Visit Report – Siemens Electrical Apparatus Ltd (SEAL)

Troubleshooting on SEAL Button Fragile/brittle fracture Issue (TR55 Green L10489.11)

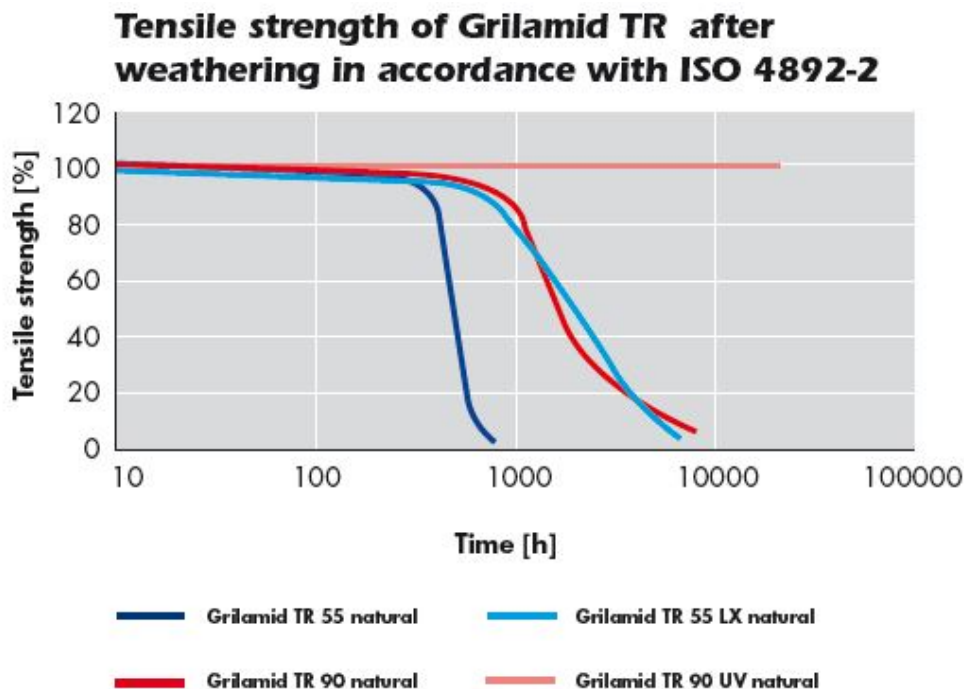
Requiring from SEAL:

- Ø Is this broken issue accidental (due to processing issue, etc) or inevitable (due to poor weathering resistance?)
- Ø How to verify above assumption and prevent its happening in the future?
- Ø Could SEAL continue ship this green button product to its customer?

- #3: SEM test by SEAL

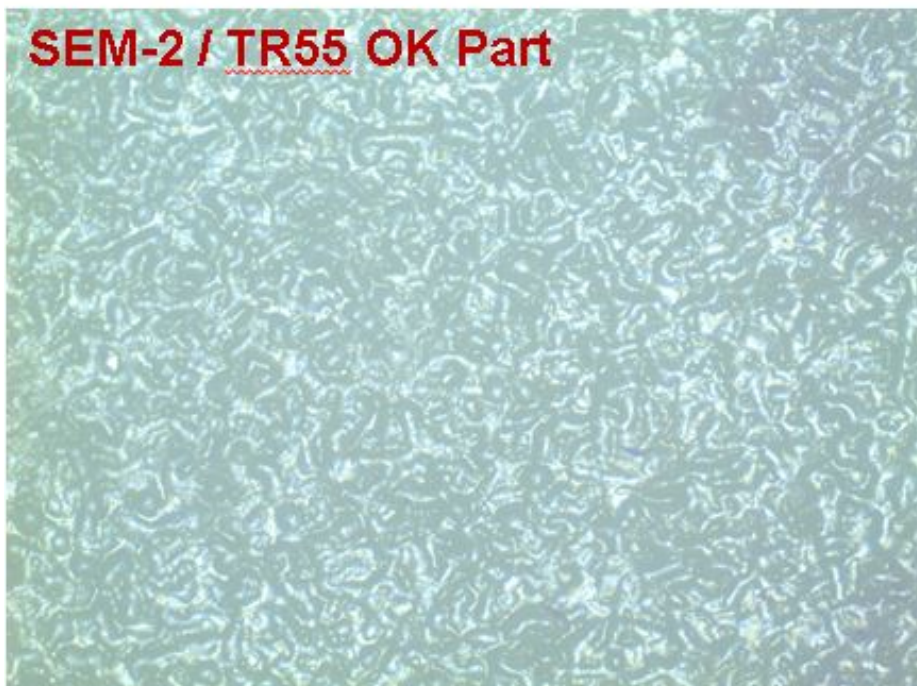
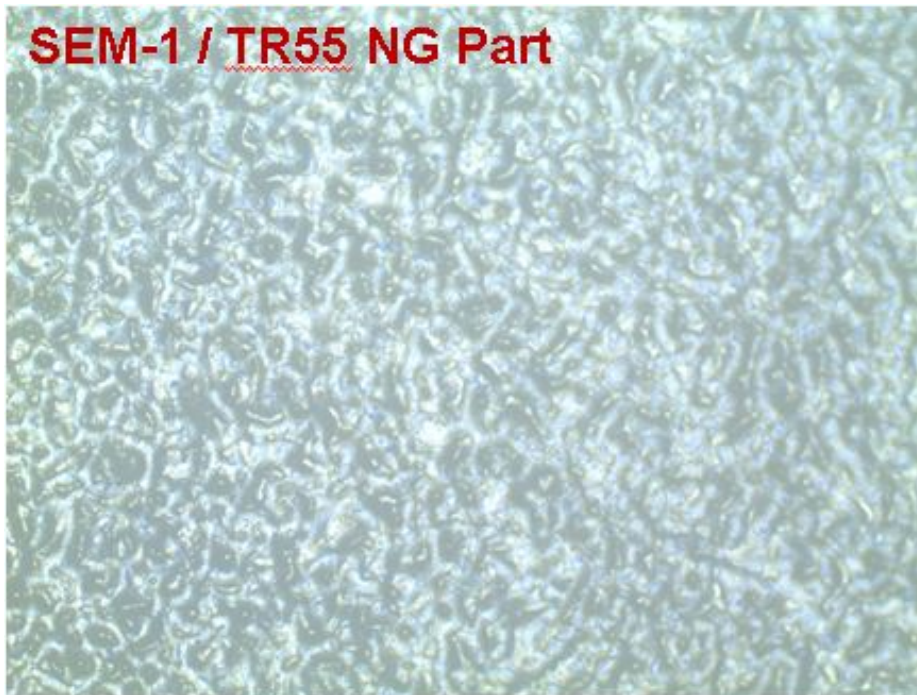
- SEAL's Tiantai didn't use desiccant dryer at the very beginning of production (installed later around in 2017).
- Is this poor performance due to not sufficient material drying?
- But Red button, yellow button were also ever produced at the same time with Green button, and didn't show problem so far

- Possible test plan

Test item	NG Green button, Produced before 2018	OK Green button, Produced in 2019	OK Red button	OK Clean color button
Viscosity	a	a	a	a
DSC	a	a		
TGA	a	a		
Weathering/ Aging (ISO 4892-2)		a		a
